# 2/22/21 ADOPTED OBJECTIVE DESIGN REVIEW STANDARDS

## ADDITIONAL AAPS COMMENTS -- 6/2/22

**Subject: Objective design review standards (Item 7-C on Historical Advisory Board’s 4-6-23 agenda and Item 5-A Planning Board’s 4-10-23 agenda) –AAPS comments.**

**Subject: Draft Revised Objective Design Review Standards (Item 4-A on Historical Advisory Board's 6-1-23 agenda and tentatively scheduled for Planning Board's 6-26-23 meeting) – Preliminary AAPS comments.**

FIGURE 1:

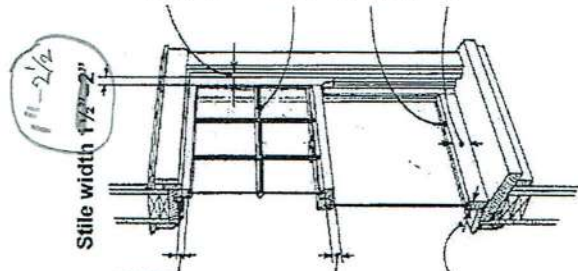
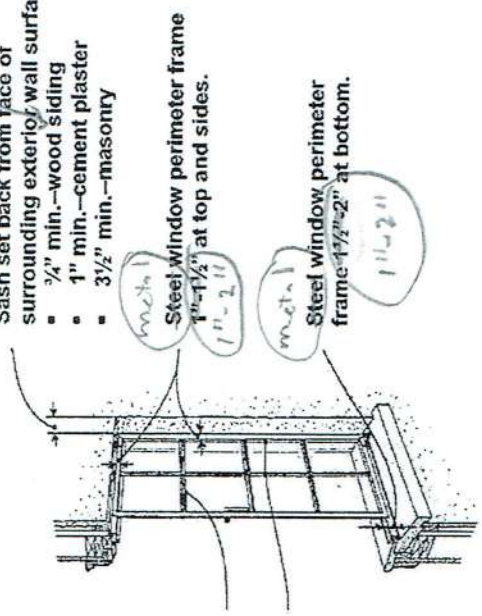
We have suggested modifications to the dimensions in the attached diagram to provide more flexibility. In addition to the changes shown on the diagram, the 3/8” recess of the glazing from the surrounding stiles and rails and for the thickness of any muntins as shown on the diagram should be changed to 5/16”.

## TYPICAL DIMENSIONS OF WOOD AND STEEL WINDOWS

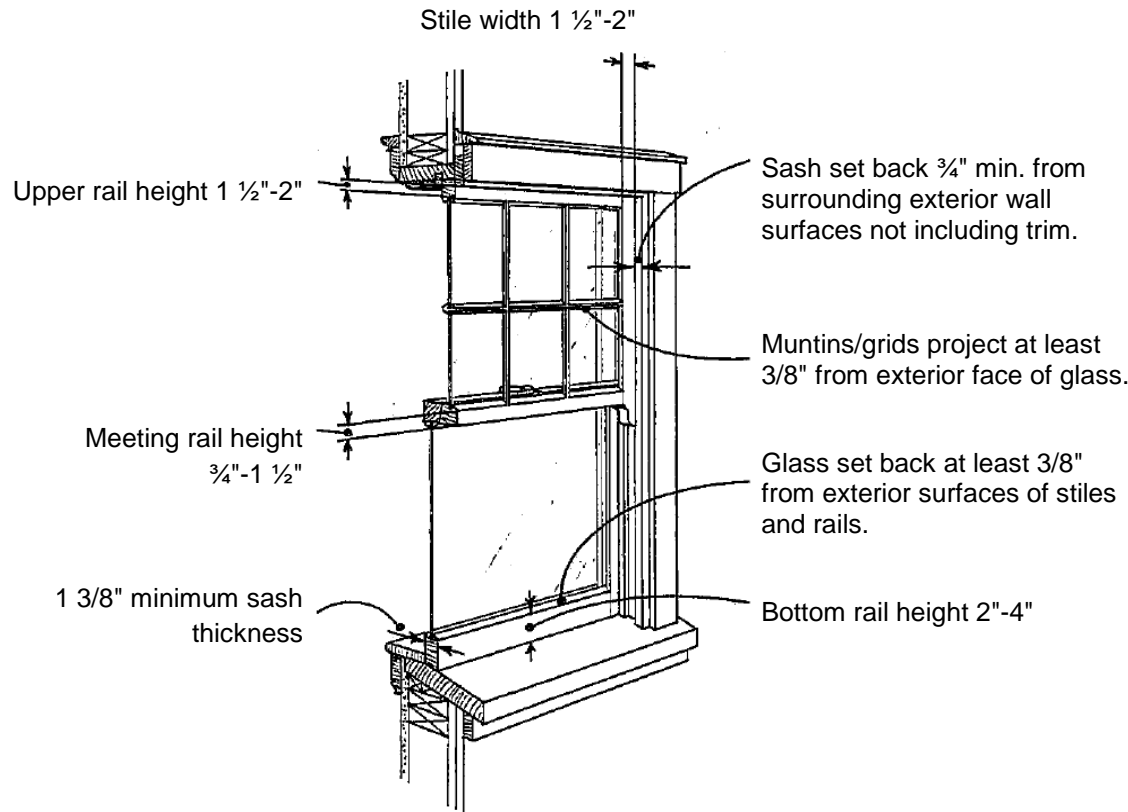
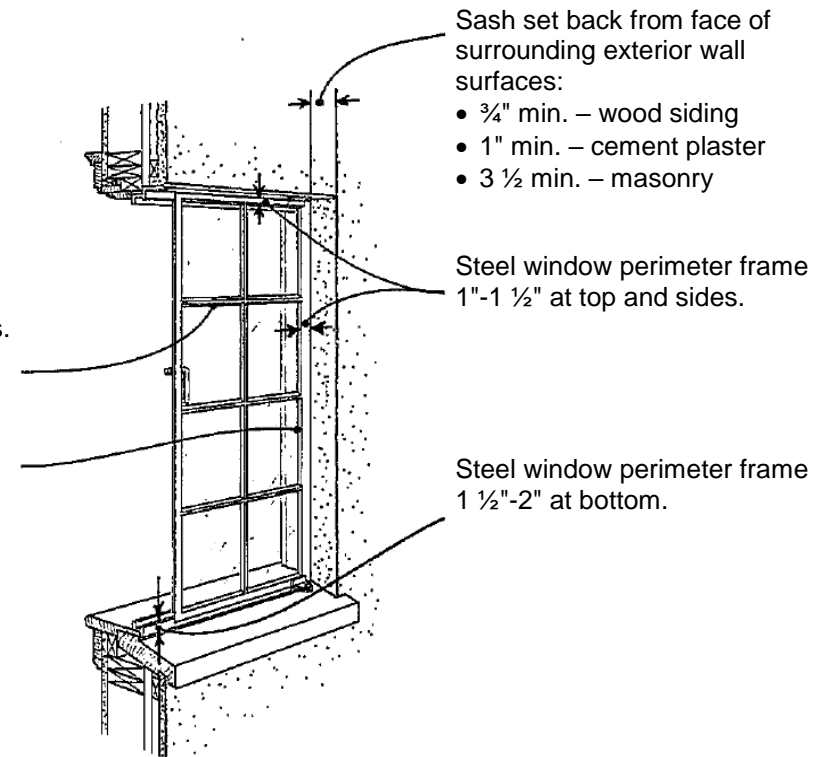
2. **Windows.** Require new windows to be consistent with the City's Replacement Window Styles Guide (Attachment 7), including the diagrams for wood and metal windows, with the understanding that alternative materials are permitted as long as the windows conform with the diagram dimensions and other provisions. See also Comment B.6 above.
